U.S. NUCLEAR REGULATORY COMMISSION

Report No: 50-263/96009(DRS)

Facility: Monticello Nuclear Generating Station

Monticello Nuclear Generating Station, Unit 1
NRC Inspection Report 50-263/96009(DRS)

FIGURE 5.2-17 Suppression Pool Temperature Response

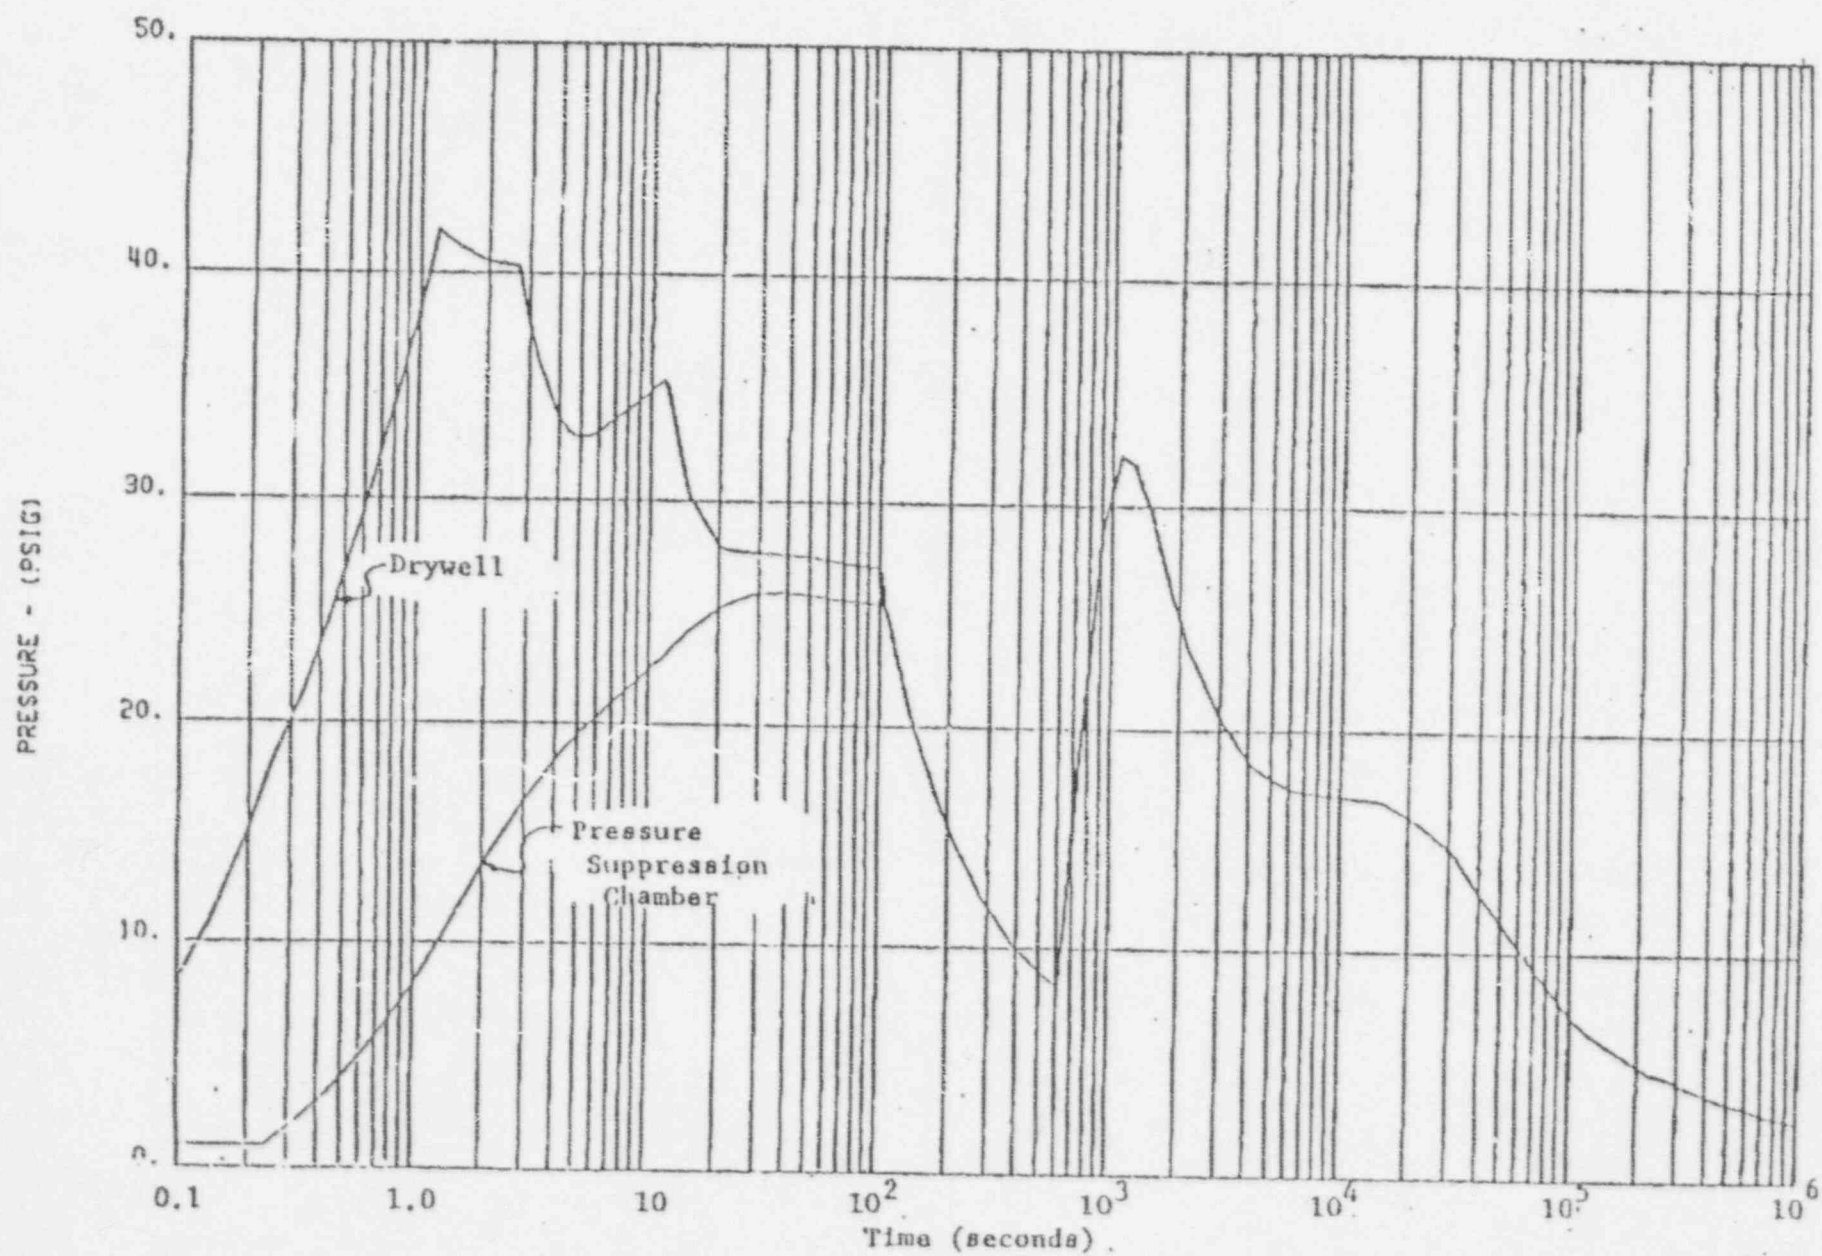
- The inspectors noted that page 2 of FOI 92-0032 stated that "...the peak pool temperature would probably be higher than that illustrated on Figure 5.2-17 and listed on Table 5.2-4 of the USAR." On page 3, under the conclusions, the following is stated: "The USAR lists a peak suppression

pool temperature of 182°F for an assumed combination of 1 CS pump, 2 RHR pumps, and 2 RHRSW pumps. A new analysis has been performed for the reduced combination of pumps that could be powered from a single EDG (i.e., 1 CS pump, 1 RHR pump and 1 RHRSW pump), and the peak pool temperature was determined to be 167.3°F." Although the conclusion noted that additional analysis "may be required," there did not appear to be any questioning, during review of the FOI, of why the reduced number of pumps would cause the suppression pool temperature to decrease rather than increase and whether the analysis results were acceptable.
